AKG

SERVICE

D 112 E

D 112 2220 Z 0001, -2220 Z 0002-**A:** first production run**B:** current production

Stand adapter / Stativanschluss

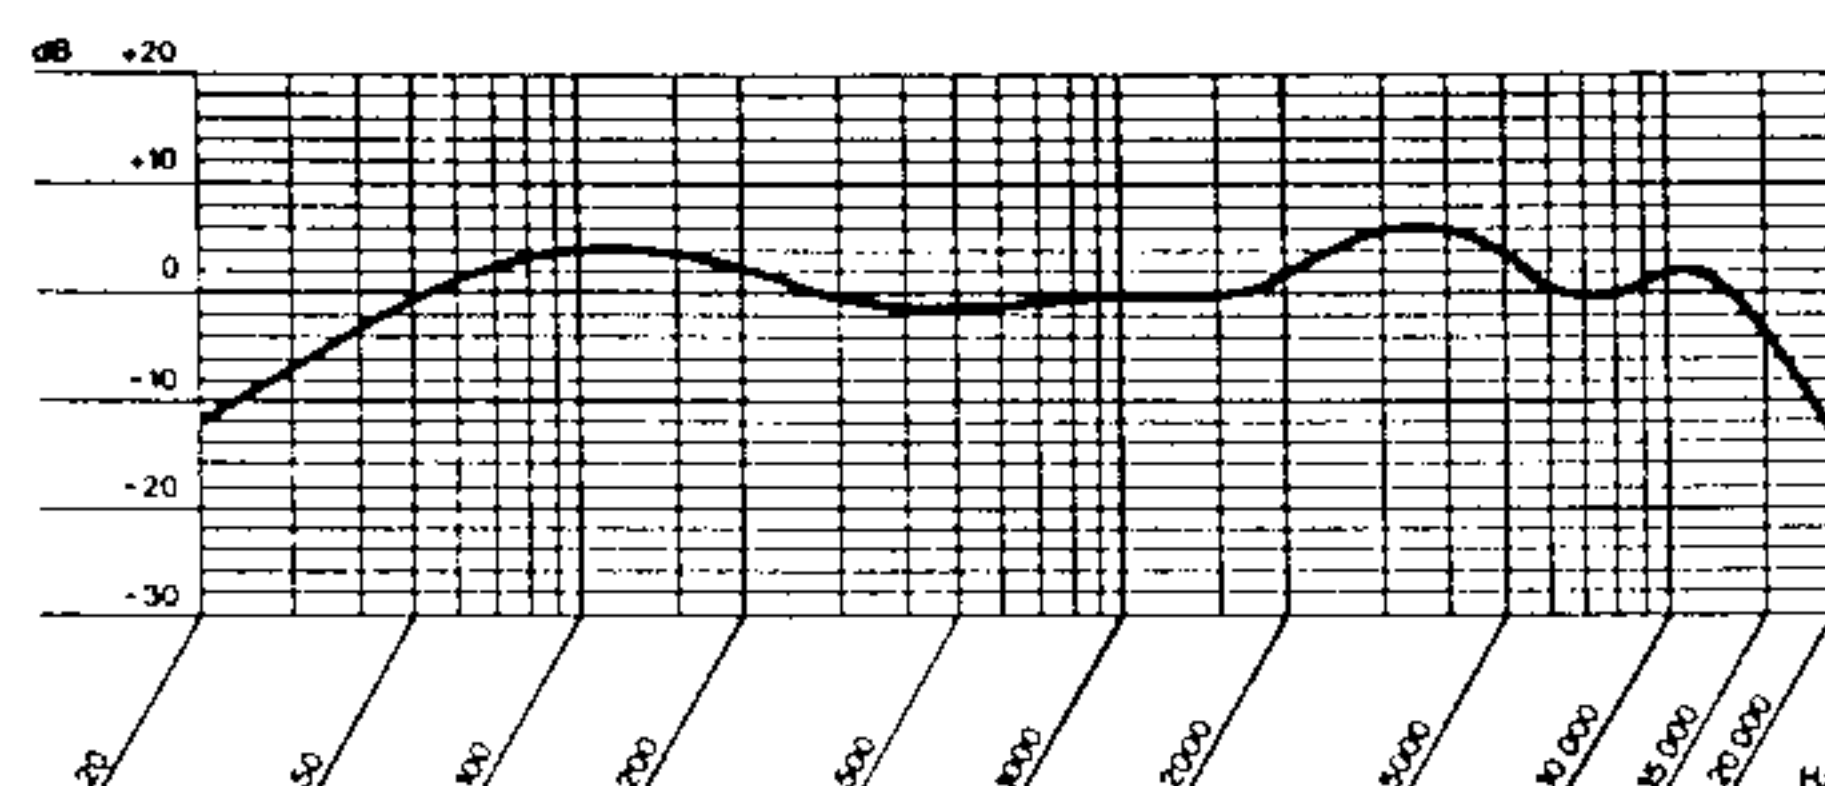
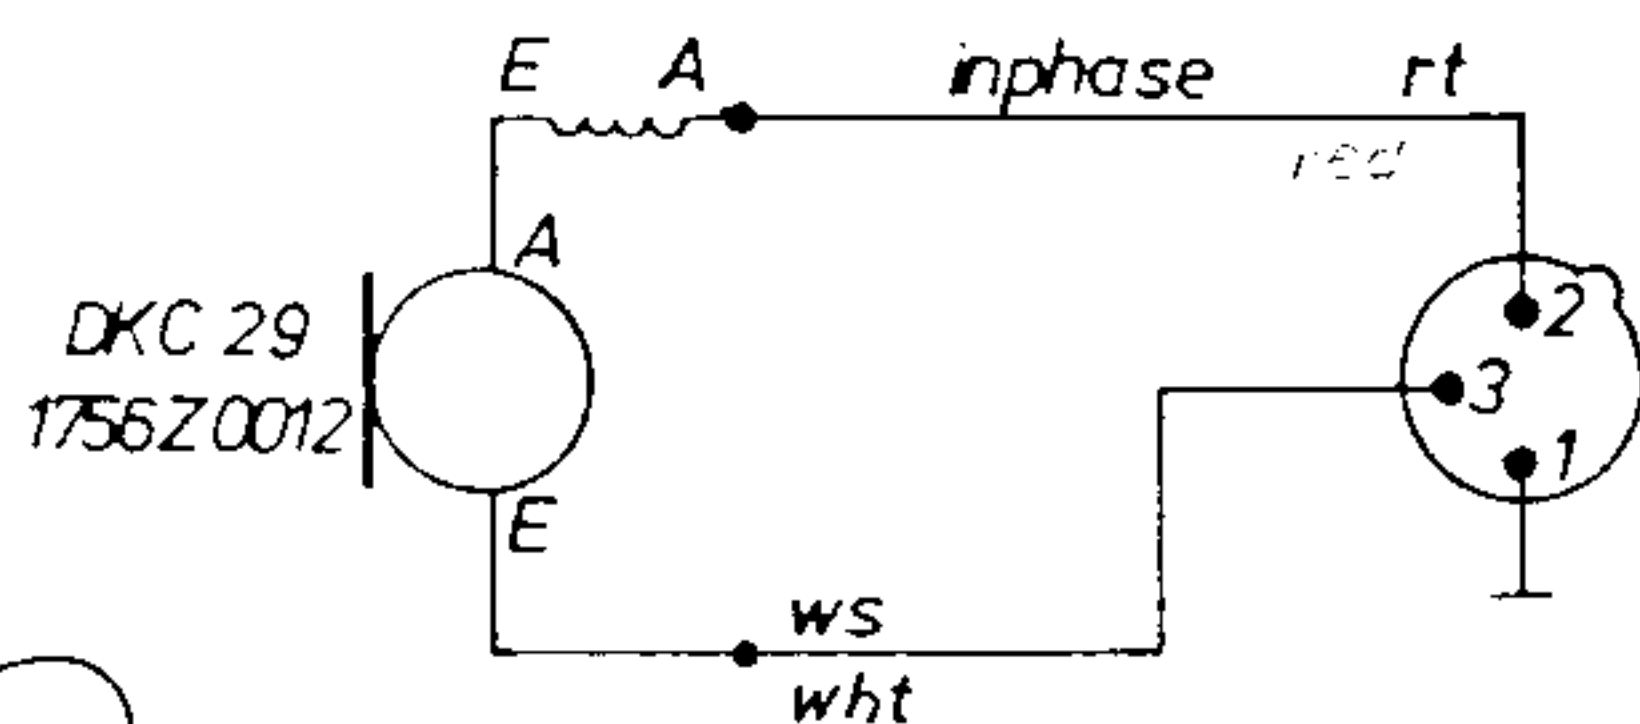
Former Version/Früher verwendbare Version:

SA40 6001H0311 available as a service item / Serviceteil

Recent Version/Derzeit verwendbare Version:

SA60 6001H6001 available as a sales item/Vertriebsware

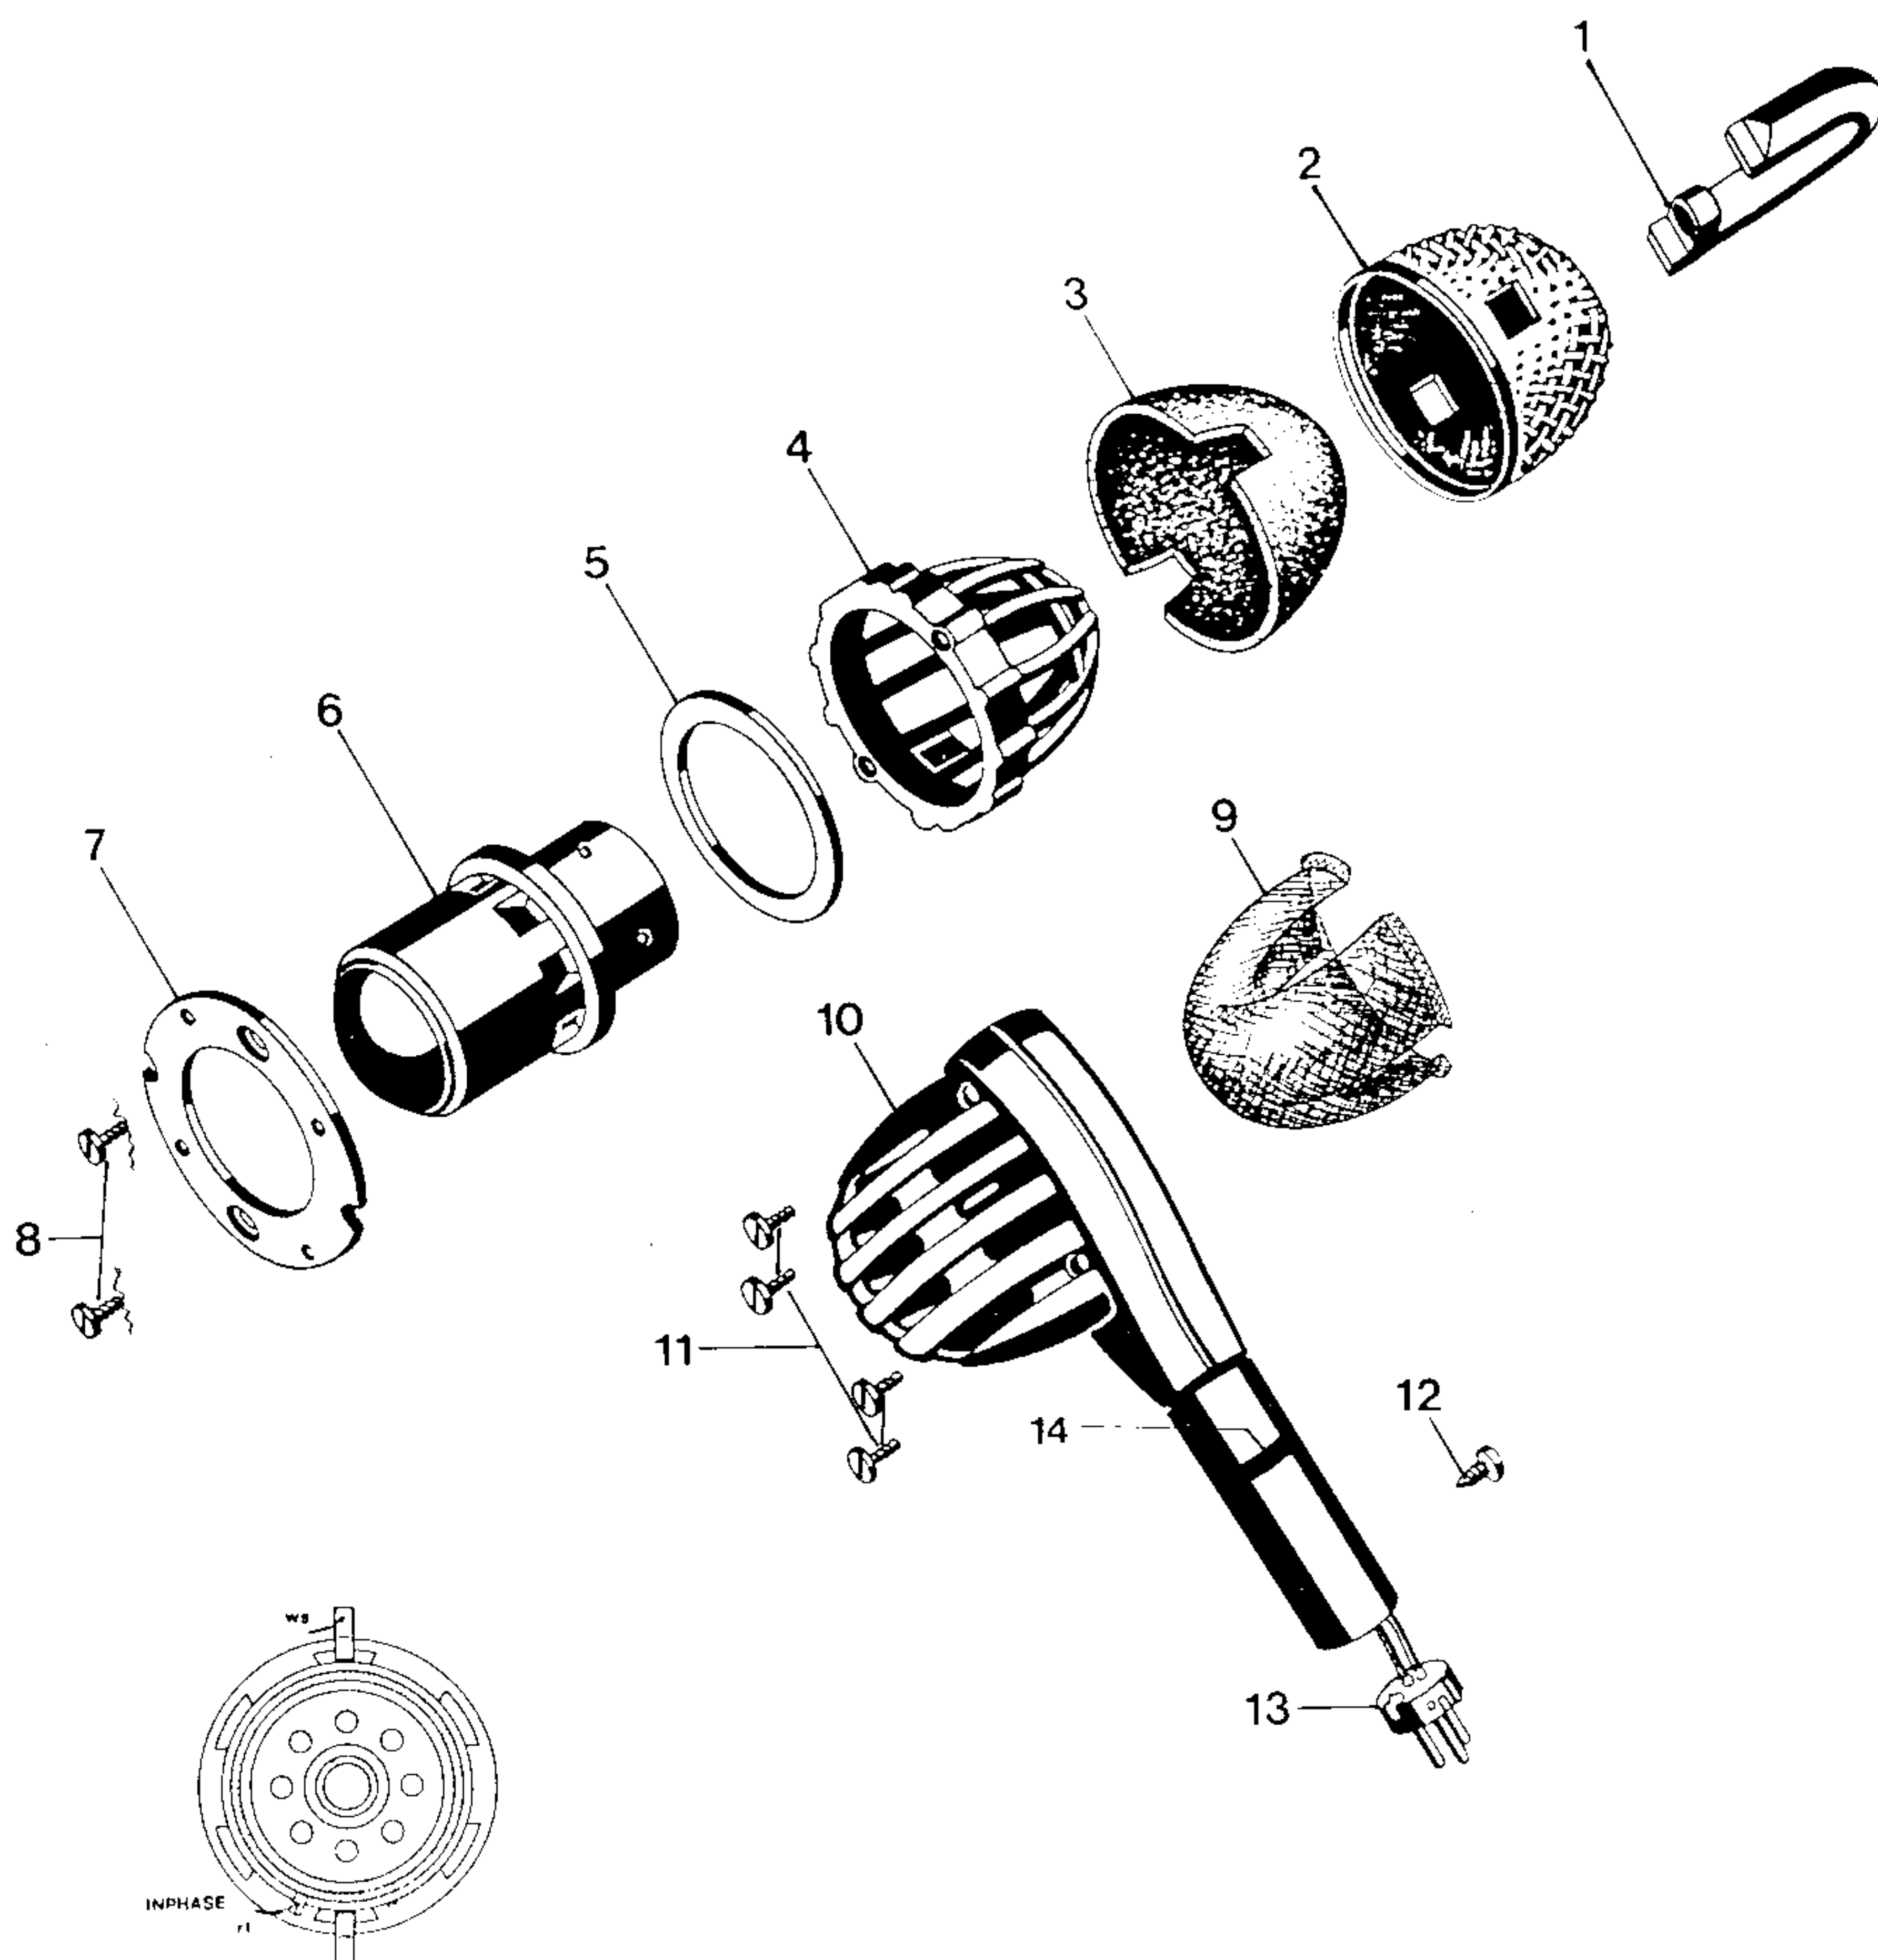
Neuerdings wird der Bügel 1 mit selbstschneidenden Schrauben (8) befestigt. Zum alten Bügel 2220M0301 mit Gewindeeinsätzen gehören die Schrauben 0084D3020, zur neuen Bügelversion 2220Z0901 die Schrauben 0099N3004. Ebenso wurden die Schrauben 11 auf selbstschneidende Versionen umgestellt. Teil 0099N3000 war eine Zwischenlösung. Gleichzeitig wurde auch der Ring 7 von 2220Z1101 auf 2220Z1201 geändert.

Recently ring 1 is fixed with selftapping screws. Screws 0084D3020 belong to the former ring version 2220M0301 with metal thread inserts, while for the new ring 2220Z0901 screws 0099N3004 are necessary. Also screws 11 have been changed to selftapping versions (0099N3000 was an intermediate variation). At the same time the ring 7 was modified (2220Z1201 instead of 2220Z1101).

Beim Wiedierzusammenbau eines zerlegten D 112 muß der Steckereinsatz 13 entfernt und die Litzen straffgezogen werden. Erst dann kann das Gehäuse zusammengebaut werden. Im Anschluß daran ist der Stecker wieder anzulöten. Diese Vorgangsweise ist unbedingt einzuhalten, da sonst die Litzen zwischen Hauptkörper 10 und Ring 7 eingequetscht werden können. Mikrofone die mit Fehlerangaben wie "kracht", "Geräusche", oder "Brumm" retourniert werden, haben höchstwahrscheinlich eingeklemmte Litzen. Prüfen Sie in diesem Fall das Mikrofon bitte mit angelegter Phantomspeisung. Damit können Feinschlüsse zum Gehäuse festgestellt werden.

When assembling a dismantled D 112, the plug insert 13 has to be removed. The litz wires have to be tightened. Then the microphone can be put together. Only after that the plug can be remounted. This procedure prevents crushing of litz wires between housing 10 and ring 7. Microphones returned with errors like "hum", "noisy", "crackling sound" will most likely have the litz wires damaged. In that case please test performance of microphone with attached phantom powering. This will reveal any shortcircuit to the housing.
